RESPONSES TO THE
U.S. NUCLEAR REGULATORY COMMISSION
REQUEST FOR ADDITIONAL INFORMATION
ON THE WEST VALLEY DEMONSTRATION PROJECT
PHASE 1 DECOMMISSIONING PLAN

GROUP 1 RESPONSES

August 14, 2009

U.S. Department of Energy
West Valley, New York

Figure F-2. Leachate Transfer Line Routing From NDA to Lagoon 1 (based on drawing 40C-S-1057)

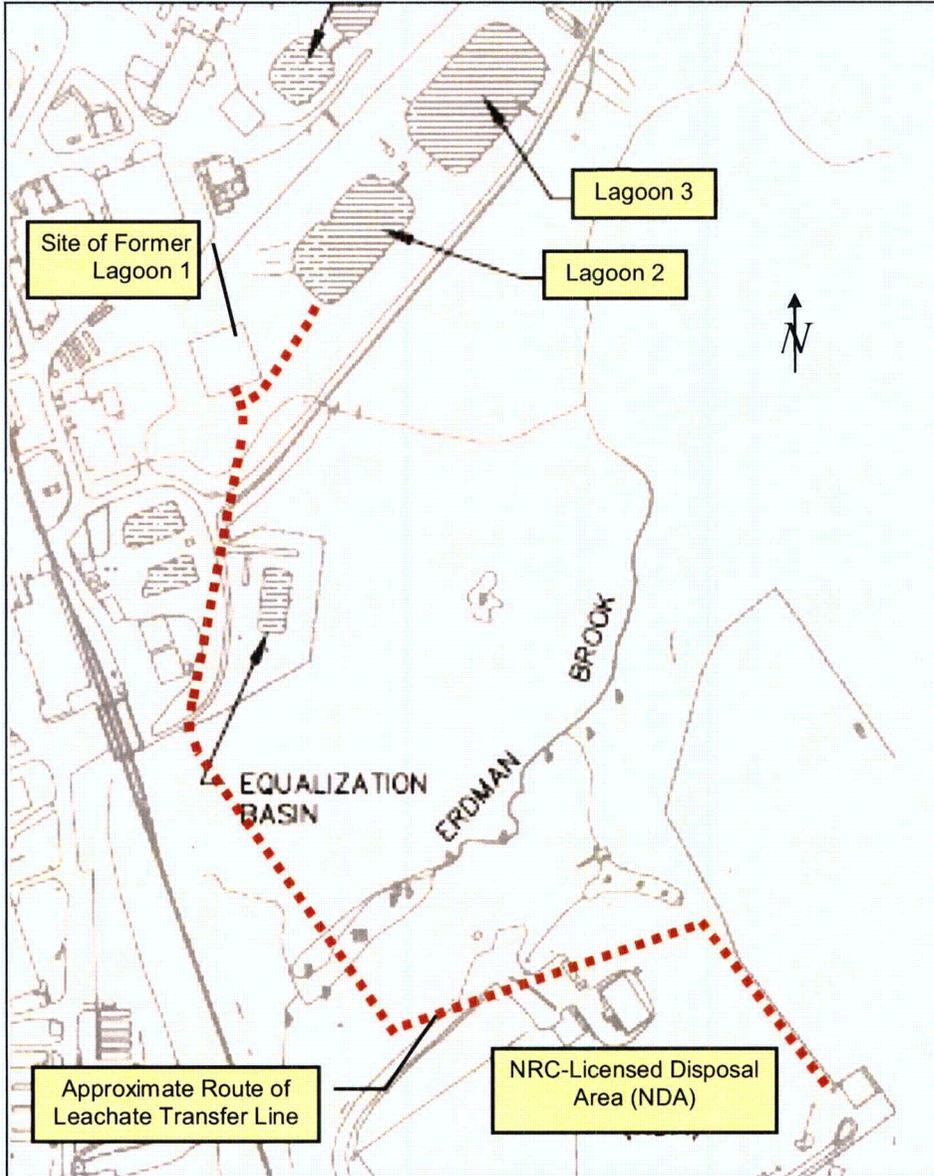
Basis: The figures (such as Figure 2-3) in the Decommissioning Plan (DP) provide current and previous locations of radionuclides, but do not clearly show the locations, depths, and distributions of piping that will be removed as part of the Phase 1 DP. The description on page ES-8 identifies underground piping generally, but does not provide a complete description of the likely distribution and magnitude of activity, or how the piping inventory estimates were developed.

Path Forward: Provide a description of the locations, depths and distributions of piping as well as estimated radiological inventory associated with the piping.

DOE Response: DOE will include information on the underground lines in a new appendix to the DP. A copy of this appendix, which is based on the radioisotope inventory report (Lockett, et al. 2004), is attached.

The line was originally used to transfer fluids originating from the SDA Lagoons to Lagoon 1 in the LLWTF via a pumphouse adjacent to the NDA hardstand. More recently, it has been used to transfer groundwater from the NDA interceptor trench to Lagoon 2. The total length of the line is approximately 2,000 feet. The location of the Leachate Transfer Line is shown on Drawing 40C-S-1057, on which Figure F-2 is based.

Figure 7-6. Conceptual Layout of WMA 1 Excavation (Showing underground structures and underground lines.)

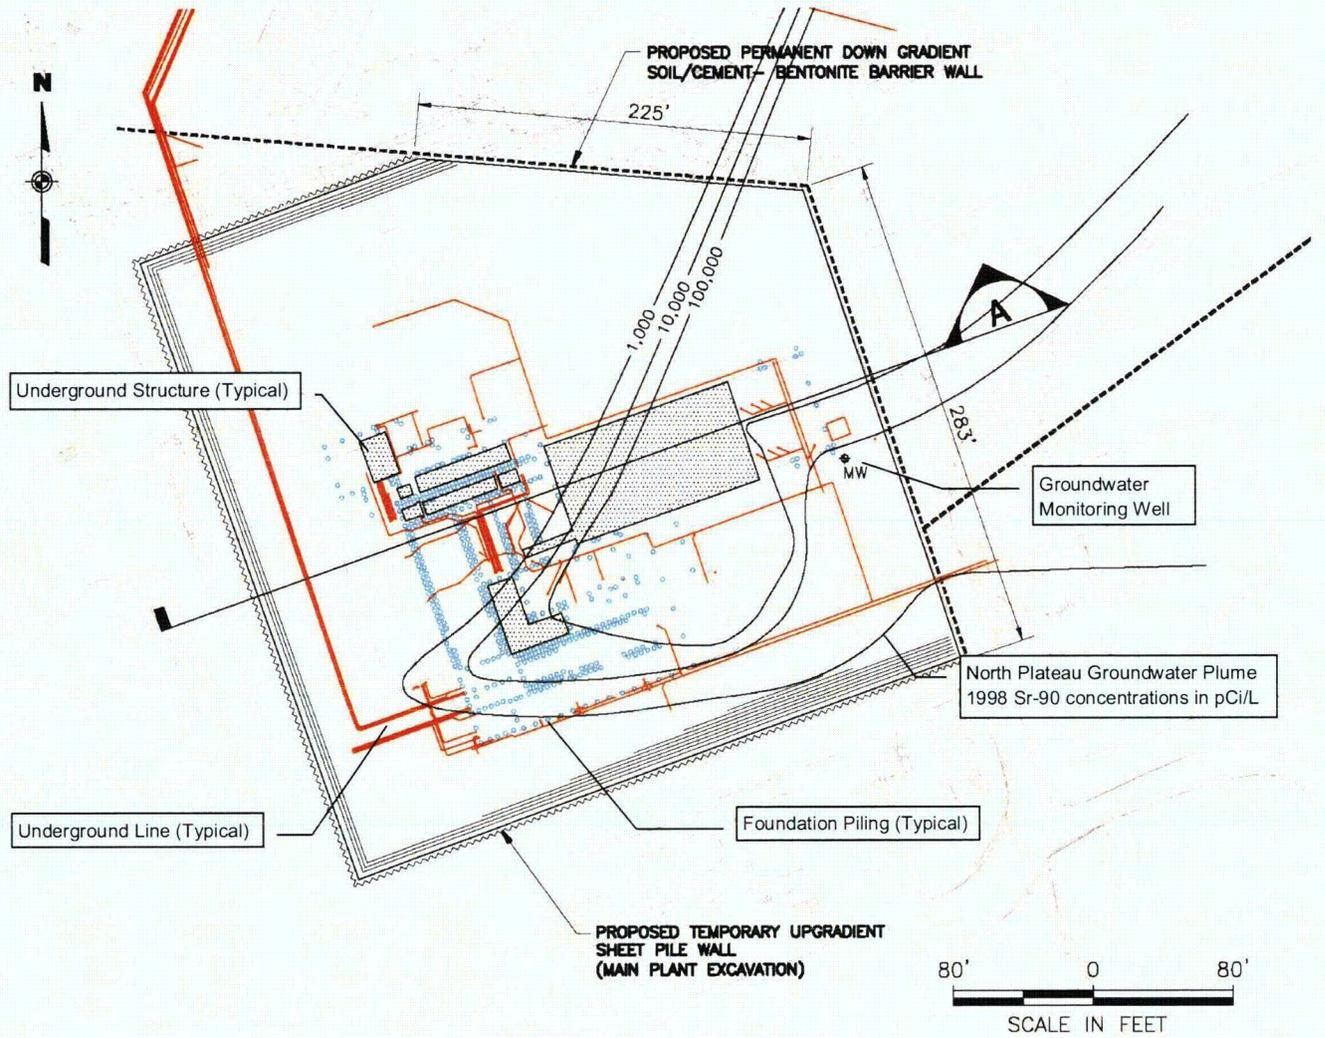
NRC Path Forward: Provide a description of the areal and vertical extent of sampling for contamination that has been completed associated with the H-piles and other discrete engineered features relative to past major spills, leaks, or known large sources of activity.

Figures 7-6 and 7-8 will be replaced with the figures shown on the following two pages, which show the pilings and better show the underground lines.

Figure 5C6-1 Recreationist Conceptual Model Cross Section

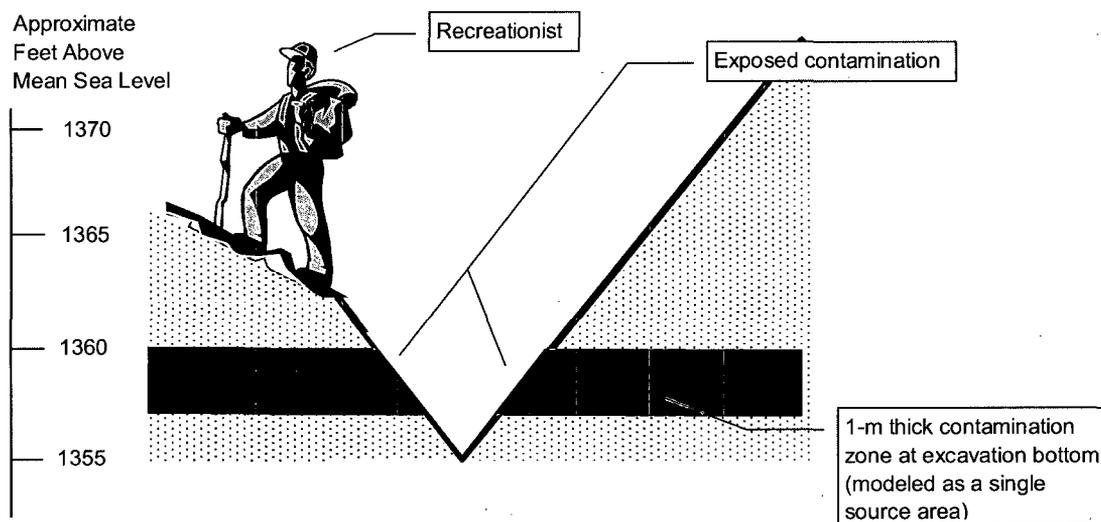
RAI: DOE did not provide enough information to show that the subsurface DCGL calculations considering a cistern drilling scenario are bounding. (Section 5.1.4, Page 5-14)

DOE acknowledges that gully erosion could intrude upon the lagoon areas (see page 5-14). However, DOE did not provide quantitative support for its assumption that erosion from gully formation/advancement, or stream widening could intercept the WMA 2 source areas and produce greater exposures to an offsite or onsite receptor.

Path Forward: DOE should provide the results of a quantitative analysis that supports its assumption that the subsurface DCGLs calculated assuming a cistern driller scenario bound the potential impacts from erosion.

A plausible scenario for these conditions would involve a recreationist spending time hiking in the area, which is assumed to be rent by deep gullies that extend to the bottom of the WMA 2 excavation. Figure 5C6-1 illustrates the basic conceptual model. This scenario was analyzed using RESRAD in the deterministic mode with the following key conceptual model input parameters:

- The exposed contamination zone area in the gully walls is assumed to be two meters wide and 100 meters long, a reasonable size to represent the likely geometry of the exposed contamination in the gully (modeling a single source area rather than the two illustrated in Figure 5C6-1 was more practical);
